Petition Number: #2022-096

From: Jake Carpenter, PE Reviewer: Travis Miller

#### **General Review Information**

Reference (CLDSM standard detail U-05A and U-03A) for street typical.

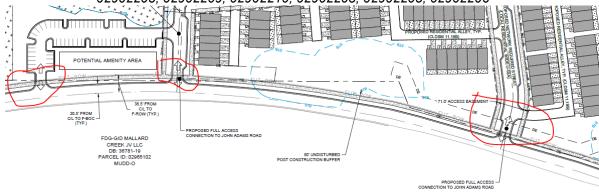
6. The proposed dwelling units exceeds 12 per acre. Per Chapter 20 Subdivision ordinance, site plan and conditional note(s) revisions are needed to commit to construct an 8-foot planting strip, and 8-foot sidewalk along John Adams Road, Galloway Road and all internal network required public Streets. The wider sidewalk also meets the Charlotte WALKS Policy.

Clarifying comment 6.21.2023: Label and dimension 8 foot planting strip and 8 food sidewalk on all internal public streets.
